# Comhairle Chontae Atha Cliath Theas

## Record of Executive Business and Chief Executive's Order

**Reg. Reference:** SDZ22A/0007

**Proposed Development:**

*Figure 3 no turning area at the end of Homezone*

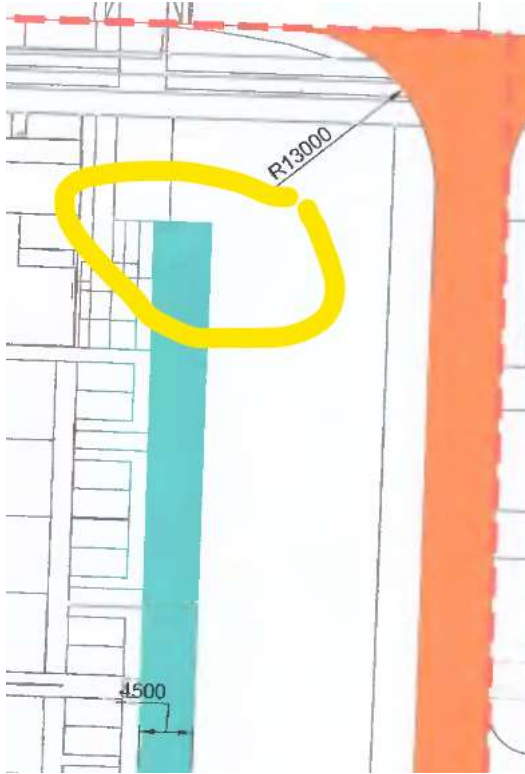
*There are no turning locations at the end of homezones 3 and adjacent to the linear park, depending on the parking arrangements and the width of the road reversing could be difficult*  
Figure 3.

- a. A revised layout of not less than 1:200 showing a turning area at the end of Homezones adjacent to the linear park, or an autotrack showing vehicle manoeuvres to allow safe turning.
- b. A revised layout of not less than 1:200 showing the road layout for the vehicle access at the northern end with Adamstown Way.

Figure 5 Boulevard cross section

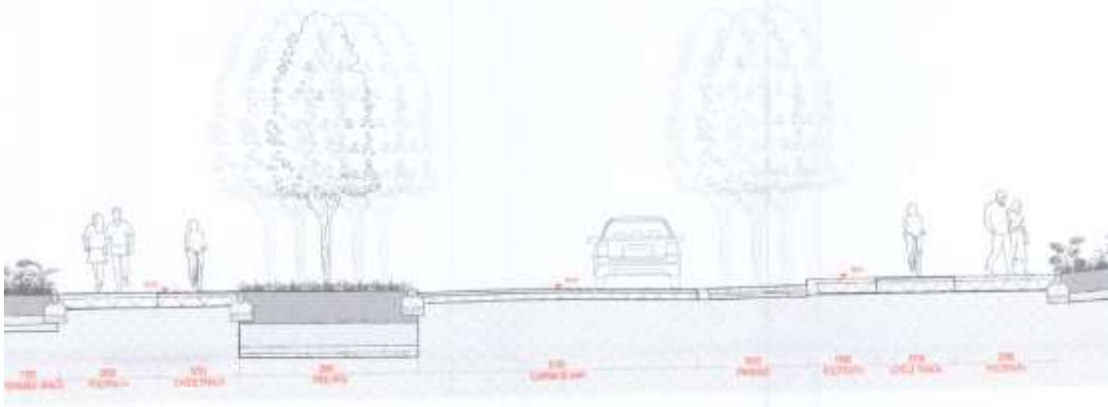
Figure 5 highlights a junction from the development close to another junction on Adamstown Way, the chevrons on Adamstown Way should be altered to allow right turning out of the proposed development.
